AIRWORTHINESS DIRECTIVE

GFA AD 609 Issue 4

Type Certificate Holder	Allstar PZL Glider Sp. z o.o.
Manufacturer(s)	PZL Bielsko
Types/Models Affected	SZD-50-3 "Puchacz"
Serial Numbers	All
Subject	Introduction Of Extra Cable Segment In The Rudder Control.
Implementation	MANDATORY
Background	Issue 1 addressed the inspection, identification and possible replacement of the rear seat rudder cable turnbuckle and protective sheath assembly IAW Mandatory Bulletin BE-054/SZD-50-3. This addressed fatigue caused by bending of the turnbuckle assembly from side loads applied by the rear pilot's foot. Fatigue failures of the turnbuckle could lead to disconnection of the rudder from the pedals. Issue 2 mandated incorporation of ALLSTAR PZL GLIDER Sp. Zo.o modification as detailed in Mandatory Bulletin No.BE-057/SZD-50-3/2006 "Puchacz" (Appendix A). Issue 3 added an alternate means of compliance by incorporating GFA Approved Modification Puchacz-2006-Rear Rudder Pedal Issue 1 (Appendix B). During installation of either modification it was found that variations between aircraft caused pedal rigging issues unless the specified length of the added cable segment was altered. Issue 4 allows the length o

Fig. 1

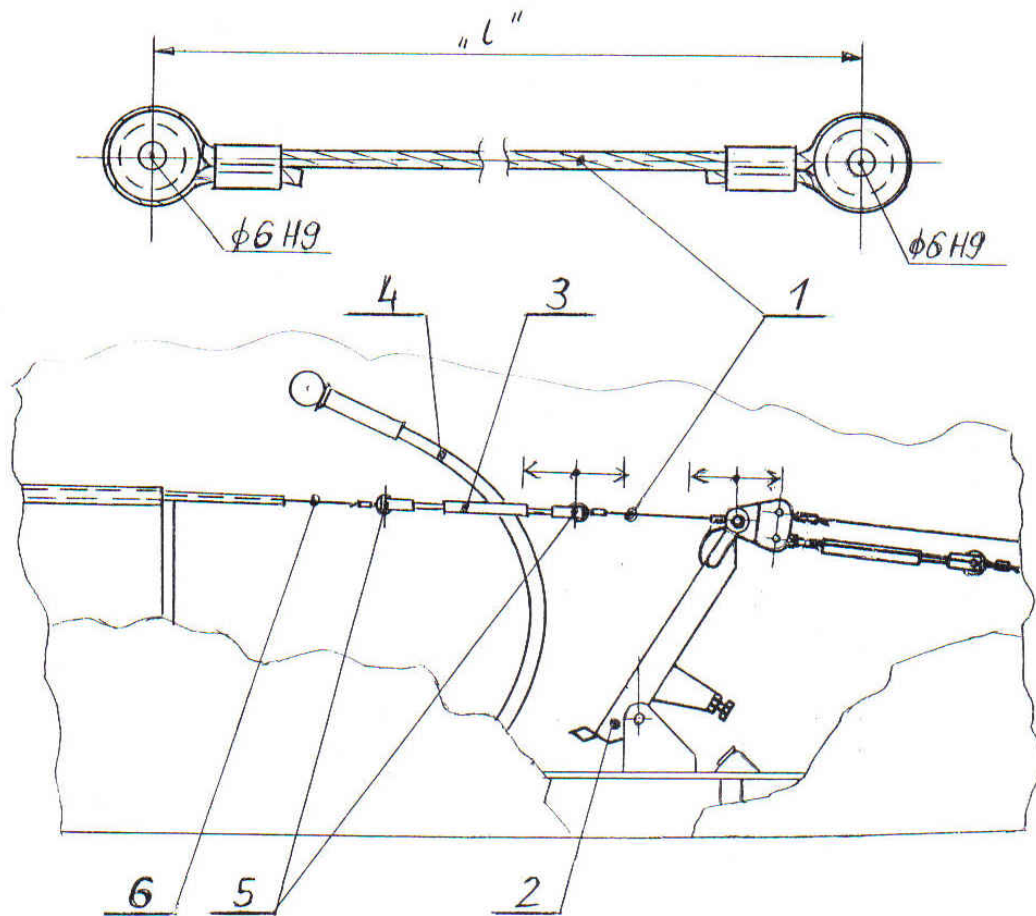
Allstar PZL Glider Sp. z o.o.	MANDATORY BULLETIN No BE-057/SZD-50-3/2006 "PUCHACZ"	Page: 2 of: 3
1. <u>SUBSTANCE OF THIS BULLETIN</u> Herewith, an extra segment of pull rod ((1) – Fig (1), of approx 140mm length “l”, is being introduced between the rear pedals (2) and turnbuckle (3) of pull rod connected to a rudder. 2. <u>GROUND FOR ISSUANCE OF THIS BULLETIN</u> This modification is aimed at elimination of the lateral load component applied at turnbuckle terminal by {pilot} foot. In several instances this has brought to fatigue failure and break of the terminal at the site of transition into eyelet. 3. <u>LIST OF FACTORY NOS COVERED WITH THIS BULLETIN</u> This Bulletin concerns all gliders of SZD-50-3 “PUCHACZ” model. 4. <u>DESCRIPTION OF MODIFICATION</u> 4.1 , On the gliders, where the eyelet terminal of the turnbuckle is connected directly to the pedals, the terminals are to be disconnected from the left-, and right pedal and scrapped. The eyelet type terminals are to be replaced with fork type with the same thread (right/left hand). 4.2 Between the pedals (2) and turnbuckle (3), install a short pull rod (1) of aircraft type steel cable with 3 mm diameter core and approx 140mm length “l”. The length is to be adjusted so that the shield of the wheel brake pull rod (4), on a left side board, remains between the turnbuckle lateral screws (5) over the whole travel of turnbuckle (fore-aft). 4.3 Shorten the pull rods (6) connecting a rudder with rudder by a value obtained by adding the length of extra pull rod with a difference between the eyelet- and fork terminal lengths. 4.4 The M4 nuts, securing the connection between the pull rod and pedal are to be of a castellated, thin type with 1 mm diameter cotter pin. 5. <u>PARTS NECESSARY FOR THE MODIFICATION</u> The parts necessary for modification are available at Allstar PZL Glider, or substitutive aircraft parts may be used – capable to withstand a load of 6100N at minimum. 6. <u>FINAL CONCLUSIONS</u> 6.1 Entry on the compliance with this Bulletin is to be done at appropriate position in a Glider Log Book. 6.2 For gliders, on which the extra pull rod segment described under item 4.2 has already been introduced, this fact is to be recorded in a Glider Log Book. Item 4.4 of this Bulletin applies.

PUCHACZ: Rear rudder pedal - Improved attachment of rudder cables

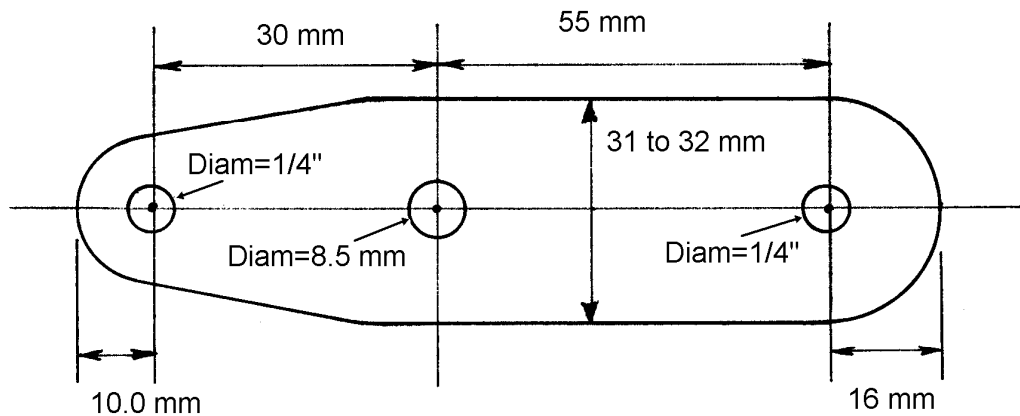
7. Manufacture two flanged bushes from high quality machining steel with 8.5 mm OD and 0.25" ID. Refer drawing below.
8. Manufacture link plates from steel SAE 4130N plate and aluminium 2024-T3 plate. Refer drawing below.

12. Reinstall pedals. The thick aluminium link plate goes on the inboard side and the thinner steel link plate goes to the outboard side. Install link plates and attach the front 1/8" diameter rudder cable and the 3/32" diameter rudder circuit completion cable re-using the original rudder cable (1/8" diam) and circuit cable (3/32" diam) to rudder pedal connecting link (steel). Use Nicopress swaging process. Attaching hardware is described below.

Link plates: 2 of 4130N steel plate, 0.40" to 0.64" thickness
 2 of 2024-T3 aluminium plate, 1/8" thickness
